Semiconductor Products Sector Application Note **AN2150**

Converting the HC08AZ32 ROM Code for the HC08AZ32A

by Tracy McHenry
Systems Engineering
East Kilbride, Scotland.

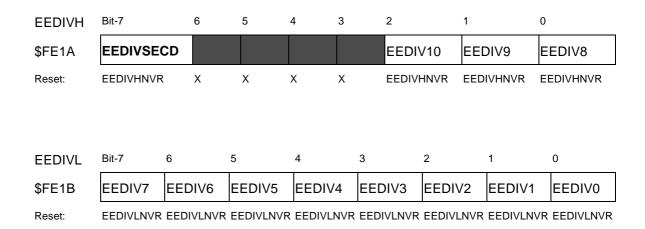
The user must exercise caution when setting up the divide ratio — EEDIVH and EEDIVL are volatile registers. They have duplicate non-volatile registers, EEDIVHNVR and EEDIVLNVR whose contents are loaded into EEDIVH and EEDIVL upon reset. However, the user should remember to correctly set up the EEDIVH and EEDIVL registers **before** attempting to program the EEDIVHNVR and EEDIVLNVR non-volatile registers. The user has 2 options listed below.

The EEDIVH and EEDIVL registers are shown below and it should also be noted that Bit-7, EEDIVSECD, of EEDIVH (and EEDIVHNVR) controls EEPROM security. If this bit is programmed to 0 after system reset the security feature is permanently enabled and the divider value in the EEDIV registers cannot be changed.

Care should be taken when setting up the EEDIVH, EEDIVL, EEDIVHNVR and EEDIVLNVR registers to ensure that setting bit-7, EEDIVSECD, does not permanently enable the EEDIV security feature. This is essential if the EEDIV register values require to be changed.

It is recommended that the required divider value is written into the EEDIV registers by writing to EEDIVL first, then EEDIVH, taking care over the value written to bit-7, EEDIVSECD of EEDIVH.
